**109 Front Street  
Winchendon, MA 01475**

**MEMORANDUM**

**FROM: Patrick Wood, Town Engineer  
SUBJECT: July 2024 Mabardy Landfill Site Observation**

Figure 1

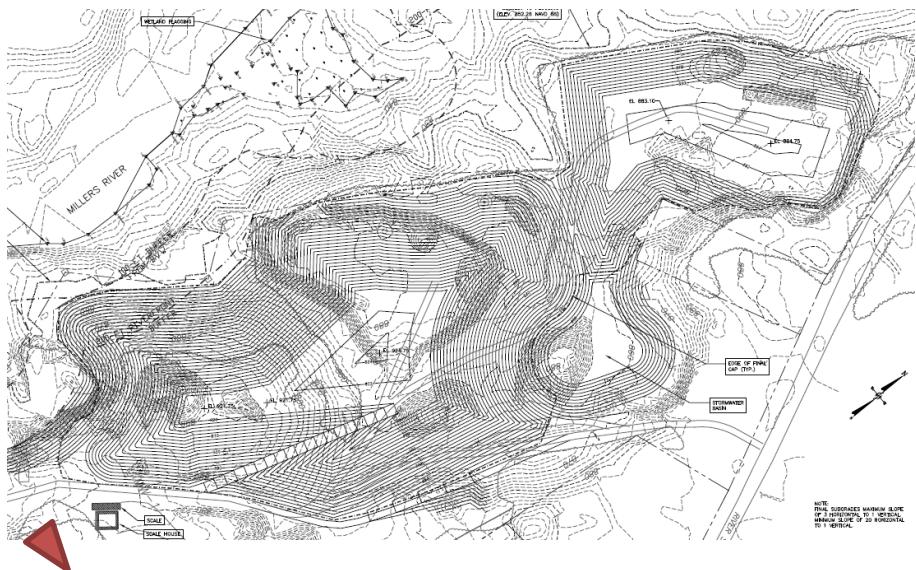
Vegetation has been growing along the hydorseeded slopes of the perimeter. Previous areas of erosion have been partially stabilized with vegetation and appear to be maintained. There are some exceptions, such as the gully that is present at the south-west portion of the site, see photo 1. These are areas of

erosion due to the sandy swales that have formed during rainfall events. Maintenance and monitoring will need to be continued in these areas to ensure there is minimal undermining and soil migration.

Monitor gullies that form in the slope. Continue to fill them in materials to remove the gullies, as possible as additional rain will continue to deepen the gullies.
